CMD : 24-M6

Accept Regulatory Document

REGDOC-1.2.3, Licence Application Guide: Licence to Prepare Site for a Deep Geological Repository

Submitted by:
CNSC Staff

Figure 1: Licensing stages and lifecycle activities for a deep geological repository

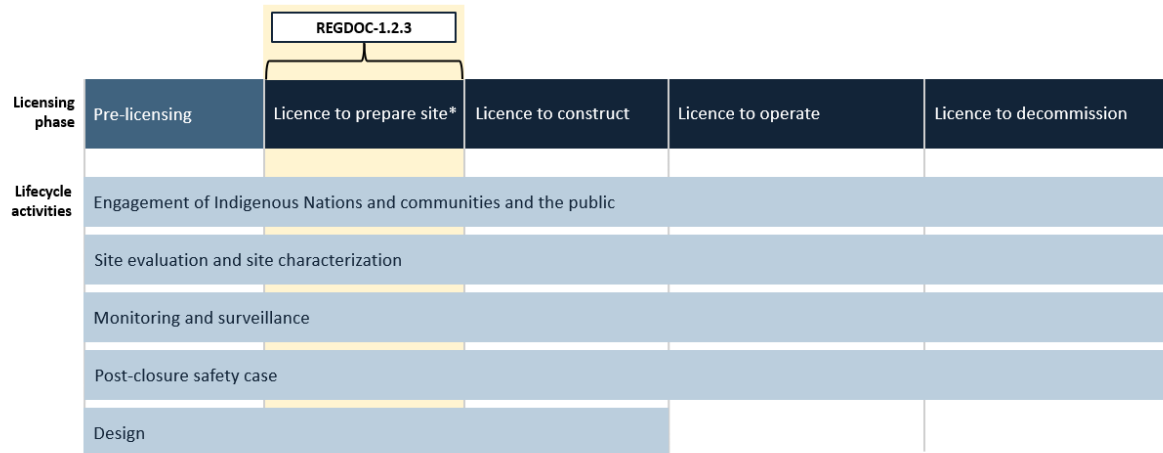
9.	Northwatch	2 Overview of site preparation	the unnumbered figure with the title "Title: Pre-closure and post-closure licensing stages and lifecycle activities for a deep geological repository" is confusing and unclear; for example, earlier sections the "safety case" and this figure introduces the term "post closure safety case" and omits any identification of the "safety case" in the table depicting project/application development			See response to comment #40.

34.	CNL, Bruce Power, NB Power, NWMO, OPG	1.1 figure on page 7	<p><i>Clarification:</i> Both Section 1.1 and figure on Page 7 acknowledges the DGR lifecycle and differentiation between pre-closure (i.e., site preparation, construction, operation, and closure) from the post-closure period. Under the Nuclear Safety Control Act what licence application will move a DGR from closure or into the post-closure period?</p> <p><i>Proposed change:</i> Provide clarification of the licence type for the post-closure period.</p>	Canadian Environmental Law Association, Concerned Citizens of Renfrew County and Area, Northwatch, Nuclear Waste Watch, Protect Our Waterways – No Nuclear Waste, Sierra Club of Canada Foundation, We the Nuclear Free North	<p>- Industry's confusion around how CNSC is differentiating between pre-closure and post-closure periods has been created by the drafters of REGDOC 1.2.3 omitting the 5th of the CNSC's five licensing steps, i.e. the "Licence to Abandon", which we presume was removed for messaging or political purposes, i.e. the CNSC wishes to avoid acknowledging that the final license will be to abandon the wastes at the selected site</p> <p>- While we disagree with a licensing approach that includes abandonment, since that is the CSNC approach and industry's intention it should be clearly stated; Figure 7 should be amended to identify the "License to Abandon"</p>	The figure was revised to exclude the post-closure period. See also response to comment #40.

39.	CNL, Bruce Power, NB Power, NWMO, OPG	2, Figure	<p><i>Clarification:</i> The first row in the figure shows the “Lifecycle” of a DGR and includes “post institutional control” as a lifecycle stage. The definition of lifecycle in the latest version of REGDOC-3.6 is “<i>The various stages of a nuclear facility’s lifespan, including site selection, site preparation, construction, operation, decommissioning and abandonment.</i>” This definition does not include the post institutional control which is post abandonment. The figure seems inconsistent with the REGDOC-3.6 definition.</p> <p><i>Proposed change:</i> Revise the figure to shade the “Post institutional control” in a different way and add a note to indicate that post institutional control is not considered a lifecycle stage per nuclear regulations.</p> <p>Alternatively, keep the figure as is and add a revised definition of lifecycle stages to the document, which includes the post institutional control as a lifecycle stage.</p>	Canadian Environmental Law Association, Concerned Citizens of Renfrew County and Area, Northwatch, Nuclear Waste Watch, Protect Our Waterways – No Nuclear Waste, Sierra Club of Canada Foundation, We the Nuclear Free North	<p>- Industry’s confusion around how CNSC is differentiating between pre-closure and post-closure periods has been created by the drafters of REGDOC 1.2.3 omitting the 5th of the CNSC’s five licensing steps, i.e. the “Licence to Abandon”, which we presume was removed for messaging or political purposes, i.e. the CNSC wishes to dodge acknowledging that the final license will be to abandon the wastes at the selected site</p> <p>- While we disagree with a licensing approach that includes abandonment, since that is the CSNC approach and industry’s intention it should be clearly stated; Figure 7 should be amended to identify the “License to Abandon”</p>	<p>Note that abandonment would include ‘post institutional control’. This is clarified in REGDOC-3.5.1 <i>Licensing process for Class I Nuclear Facilities and Uranium Mines and Mills</i> which states: The Commission may issue a licence to abandon or an exemption from licensing which will end the licensee’s responsibility for the site and then transfer responsibility for regulatory oversight or institutional control from the CNSC to the province or territory, if applicable”.</p> <p>See also response to comment #40.</p>

40.	CNL, Bruce Power, NB Power, NWMO, OPG	2, Figure	<p><i>Clarification:</i> The figure indicates the post-closure period starts after the site is released from CNSC control. However, Figure A.1 in CSA N292.7 indicates that post-closure period starts when the DGR is closed, while a post-closure monitoring period is still under the CNSC control. There are two questions:</p> <ul style="list-style-type: none"> ☐ What is the starting point of the post-closure period (closure of the DGR or release from CNSC control)? ☐ Does the CNSC control cover the post-closure monitoring activities and these activities are considered part of “Closure” and “License to decommission”? <p><i>Proposed change:</i> Seeking clarity for the starting point of the post-closure period and licensing coverage on post-closure monitoring in the document.</p>	Canadian Environmental Law Association, Concerned Citizens of Renfrew County and Area, Northwatch, Nuclear Waste Watch, Protect Our Waterways – No Nuclear Waste, Sierra Club of Canada Foundation, We the Nuclear Free North	<p>- Excellent questions.</p> <p>- This is a significant issue.</p> <p>- We propose that the CNSC prepare a discussion paper specifically on this topic and include in that discussion paper a detailed description of how other jurisdictions have made this determination and an analysis of the strengths and weaknesses of different options considered.</p> <p>- The issue is further complicated by the potentially very long time- frame for operations, and the current “adaptive repository layout” approach being described by the NWMO and the attendant potential for closure being carried out on a panel-by-panel basis; under this</p>	<p>The figure has been revised for clarity, focussing on the CNSC’s licensing phases and associated lifecycle activities.</p>

41.	CNL, Bruce Power, NB Power, NWMO, OPG	2, Figure	<p>The figure shows "indigenous and public engagement", "site evaluation", "site characterization" and "post-closure safety case" all extend beyond release of CNSC control. CSA N292.7 Figure A.1 shows these activities all stops before release from CNSC control.</p> <p>In addition, the last bullet in Section 1.1 requires the proponent "demonstrates that the site is suitable for a facility's full lifecycle."</p> <p>It is unclear what activities would be required to be maintained during institutional controls with respect to site evaluation, site characterization and post-closure safety case, and under what jurisdiction.</p> <p><i>Proposed change:</i> Seeking clarity on the inconsistency with the CSA N292.7.</p> <p>If these activities are required to continue beyond release from CNSC control, please answer the following questions:</p> <ul style="list-style-type: none"> ☐ Who is responsible to regulate these activities? ☐ How should the outcomes from these activities be used and for what purpose? <p>Suggest either deleting 'site evaluation', 'site characterization' and 'post-closure safety case' activities from the graphic or adding clarification text with respect to the regulatory requirements for these activities after the closure of the DGR facility.</p>	Canadian Environmental Law Association, Concerned Citizens of Renfrew County and Area, Northwatch, Nuclear Waste Watch, Protect Our Waterways – No Nuclear Waste, Sierra Club of Canada Foundation, We the Nuclear Free North	<p>- Industry comments that the unnumbered figure at the top of page 7 shows "indigenous and public engagement", "site evaluation", "site characterization" and "post-closure safety case" all extend beyond release of CNSC control" and asks who is responsible for regulating these activities, when in fact the figure shows these activities do not continue beyond institutional control (i.e. the CNSC license to abandon) and the question is more problematic: how is post-closure monitoring to be carried out, how are the public and Indigenous peoples to be engaged, what will the response be to unexpected monitoring results (assuming that effective monitoring can and will be undertaken and results made known)</p> <p>- Industry's question about how the outcome of monitoring and engagement activities will be used is very pertinent, but their proposed resolution that these activities be simply deleted is completely unacceptable</p>	See response to comment #40.

42.	CNL, Bruce Power, NB Power, NWMO, OPG	2, Figure	<p><i>Clarification:</i> The figure shows "site characterization" in parallel with "site evaluation". CSA N292.7 Section 6 indicates that site characterization is a subset of site evaluation, which is inconsistent.</p> <p><i>Proposed change:</i> Seeking clarity on the inconsistency with the CSA N292.7 on site evaluation and site characterization.</p>	Canadian Environmental Law Association, Concerned Citizens of Renfrew County and Area, Northwatch, Nuclear Waste Watch, Protect Our Waterways – No Nuclear Waste, Sierra Club of Canada	<p>- This request for clarification illustrates the problematic approach adopted by CNSC of referencing industry standards in Regulatory Documents, for which the public has limited or no access and which are - as noted by industry - often contradictory.</p> <p>- The resolution to this comment should be to include sufficient</p>	The figure has been revised to reflect site evaluation and site characterization in one line. Site characterization is described separately in the text to reflect its specific importance for DGR projects, in particular, and as an important aspect of site evaluation

43.	CNL, Bruce Power, NB Power, NWMO, OPxG	2, Figure	<p><i>Clarification:</i> The design phase is shown to be completed at the end of construction; what happens with construction that continues in parallel with the Operation phase? Also, design will continue in Operations to support improvements and optimization.</p> <p><i>Proposed change:</i> Continue the Design Line through Operations</p>	Canadian Environmental Law Association, Concerned Citizens of Renfrew County and Area, Northwatch, Nuclear Waste Watch, Protect Our Waterways – No Nuclear Waste, Sierra Club of Canada Foundation, We the Nuclear Free North	<p>- The question posed by industry in this comment is unclear.</p> <p>- The industry suggestion that the Design Line be continued through operations could open the door to a proponent filing an incomplete application with design relegated to a “to be determined” status</p> <p>- A license application must include a complete design as part of the project description which will be required to produce the required pre-and-post closure safety assessments; given the NWMO’s stated intention to rely on the construction period (post license to construct) to carry out site characterization activities to obtain information necessary to support their safety case (pre and post closure) this appears to be an intractable contradiction.</p> <p>- CNSC’s response to this comment from industry must be clear in the requirement for a full set of safety reports (pre and post-closure) to be filed as part of the site preparation license (and license to construct application, and license to operate application).</p>	The text has been updated to reflect that activities shown reflect typical activities for each stage. The design period as shown is consistent with CSA N292.7. While aspects related to design improvement could be expected to continue during operation - they would be managed through a design change control process over subsequent decades of active operation.

characterization. Section 2 was revised and new text added to further clarify the role of monitoring and surveillance, site evaluation and site characterization as well as to explain the various functions illustrated in revised Figure 1: Pre-closure and post-closure licensing stages and lifecycle activities for a deep geological repository. To further clarify the important role of environmental monitoring and surveillance, these activities were added to the figure and explanatory text was also added to a new section in the document, section 2.4 Monitoring and surveillance.

- CNSC staff note there are no new requirements or guidance established in REGDOC-1.2.3. The safety case for disposal is expected to evolve using an iterative approach, as outlined in REGDOC 2.11.1, *Waste Management, Volume III*. In addition, the terminology used in the draft is consistent with the associated reference documents, such as CSA N929.7, where specific terminology is used during pre-closure and post-closure periods for activities, such as assessment and analysis. Minor changes were made to the text to ensure clarity on these points. In addition, revisions were made to Figure 1: Pre-closure and post-closure licensing stages and lifecycle activities for a deep geological repository to bring focus on the CNSC's licensing phases and lifecycle activities.
